SUBJECT: Historic Area Work Permit # 1060792 - 16400 Layhill Road, Sandy Spring

The Montgomery County Historic Preservation Commission (HPC) has reviewed the attached application for a Historic Area Work Permit (HAWP). This application was **approved** at the March 20, 2024, HPC meeting.

MONTGOMERY COUNTY
DEPARTMENT OF TRANSPORTATION
DIVISION OF TRANSPORTATION ENGINEERING
HERITAGE TRIANGLE TRAIL PHASE 1
DR. BIRD / NORWOOD ROAD
SHARED USE PATH

- Montgomery County Department of Transportation to construct sidepath improvements along a 1,400 foot section of Doctor Bird Road starting at Olney-Sandy Spring Road (MD 108) heading to the south and a 1,700 foot-long section of Norwood Road starting at the intersection of Norwood Road with Layhill Road/Ednor Road intersection heading north. For construction of the sidepath on Doctor Bird Road, the project was reviewed by the Montgomery County Historic Preservation Commission. Staff Reference: MR2022024

Figure 9 – Project Impacts to Parkland

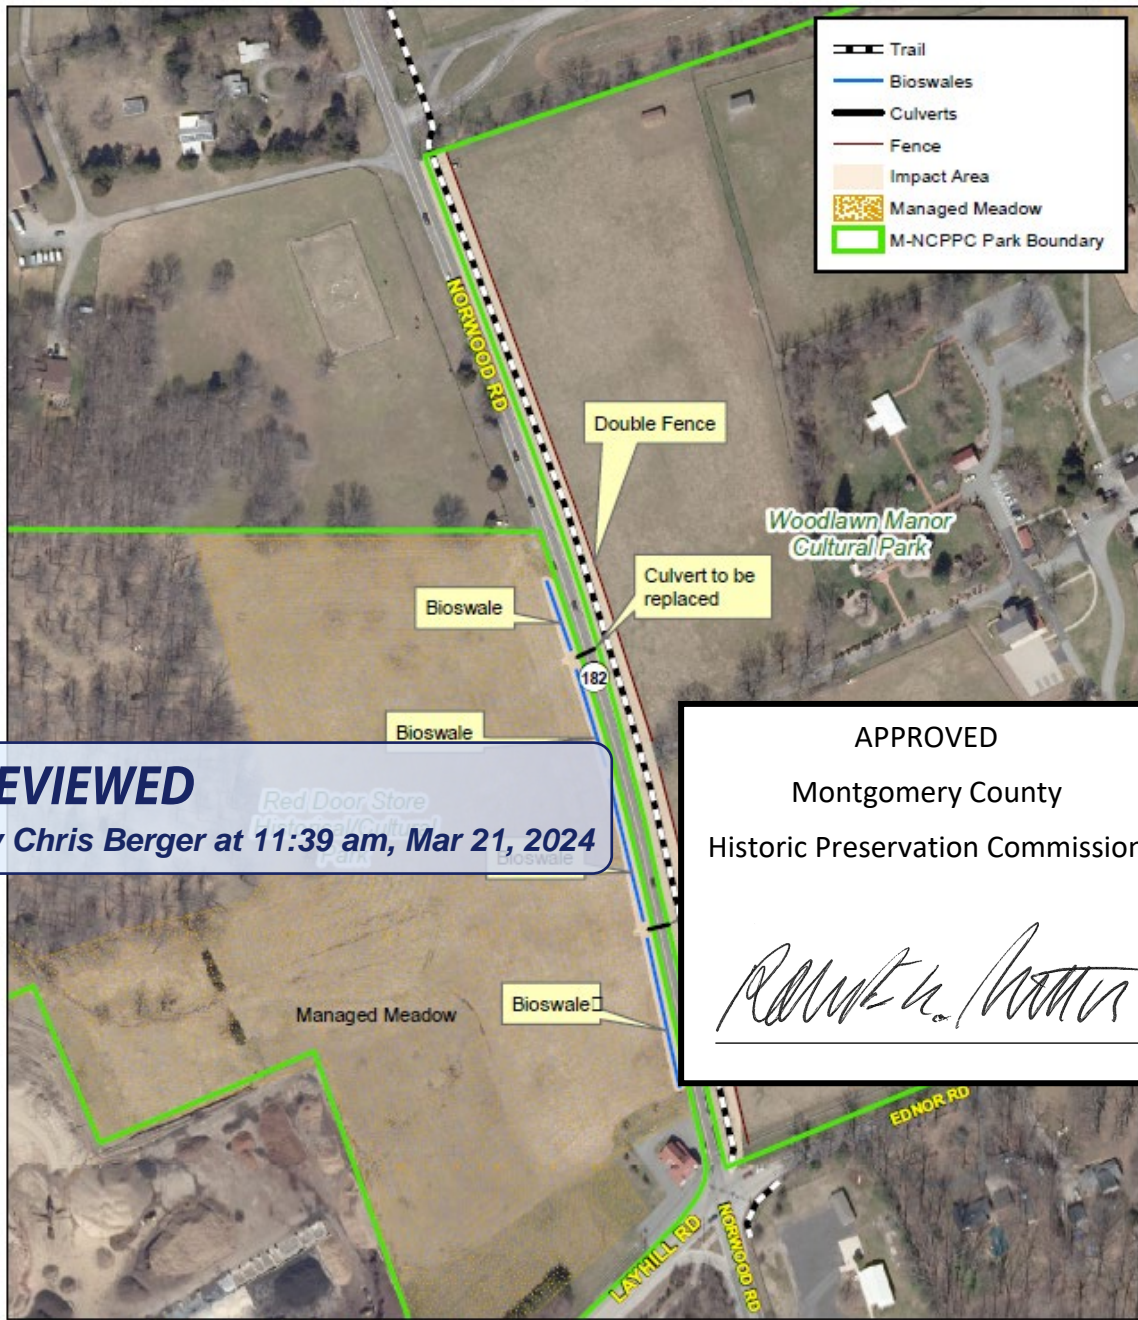
The proposed sidepath project along Norwood Road (MD182) will impact approximately 64,590 SF square feet of parkland at the frontage of Woodlawn Manor Cultural Park on the east side of Norwood Road. In addition, there are approximately 22,180 SF of proposed parkland impacts, at the Red Door Store Cultural Park on the west side of Norwood Road to accommodate stormwater management swales (Figure 9). There are no parkland impacts associated with the approximately 1,400-foot-long section along Doctor Bird Road starting at MD 108 (Olney Sandy Spring Road) and traveling south towards Norwood Road.

Montgomery Parks supports the project’s goal to improve pedestrian and cyclist connectivity to these important cultural resources and is working with MCDOT to reduce the impacts to parkland where feasible and provide appropriate mitigation for unavoidable impacts. The 10-foot-wide sidepath connector proposed on the east side of Norwood Road along Woodlawn Manor Cultural Park, includes a variable 10- to 15-foot-wide grass buffer between the path and the roadway (see Figure 7). The pasture will be reduced by 22 to 30 feet along the approximately 1,600-foot length on park property.

Figure 12 – Plan view of the proposed Sidepath at the Entrance of Woodlawn Manor Cultural Park

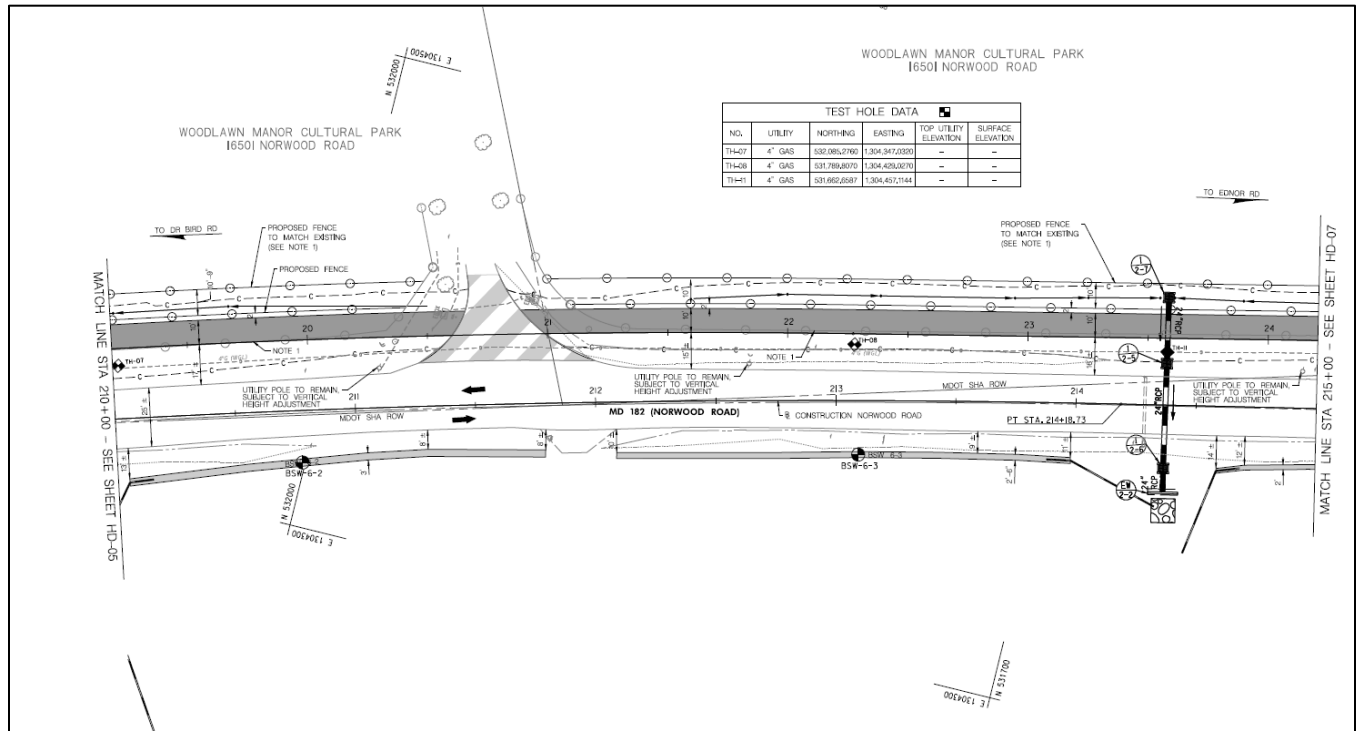
Along the length of the east side of the path, at the request of Park Police, a double fence separated by a 10-foot width is proposed to separate the equestrian pasture from the path for the safety of both the

horses and path users. The fence must match the existing fence in design and materials. In addition, due to increased access and activity that the path will provide around the Park Police headquarters and equestrian facilities MCDOT will also provide four security cameras along the frontage of the Woodlawn Property. Finally, MCDOT will provide a trail counter along this section of the path to Parks' specification to allow for user data tracking and analysis.
